BELVAC PRODUCTION MACHINERY

# TECHNICAL BULLETIN

## Advanced Air Conservation Upgrade Kit

### 590 AND 595 NECKING EQUIPMENT

## 595 Modular VE

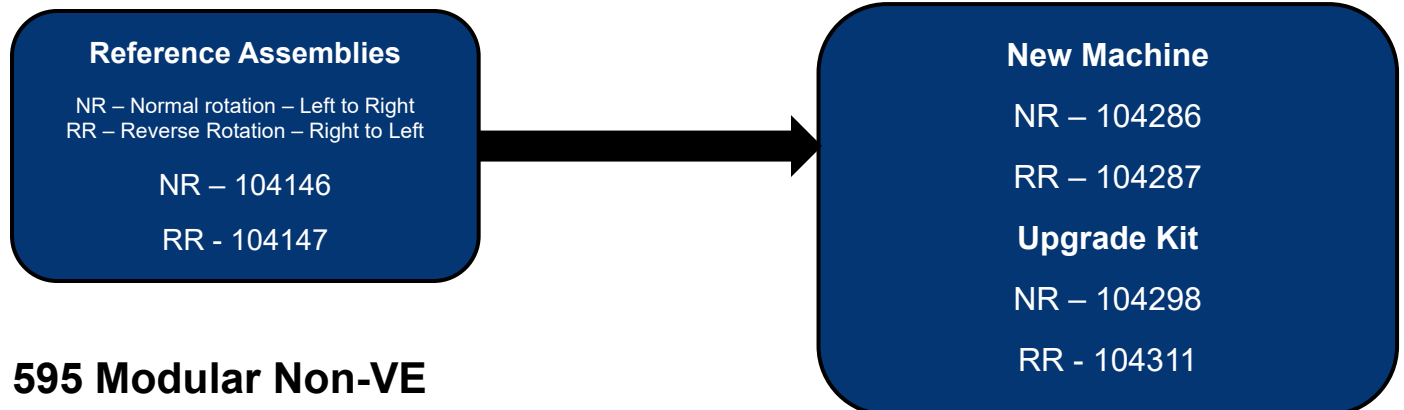
The Advanced Air Conservation Upgrade Kit replaces the existing Face Seal Manifold in the following machines: 590 and 595 Neckers. The new design improves the air consumption of Necker turrets (only necking tooling stage) by strategically controlling air distribution with the timing shoe and metering plate. Not applicable to Flanger, Reformer, or Light Tester. This design features a one-for-one size replacement with the previous FSM design. Operators can expect a 40% to 60% reduction in air consumption depending on machine configuration, style and more.
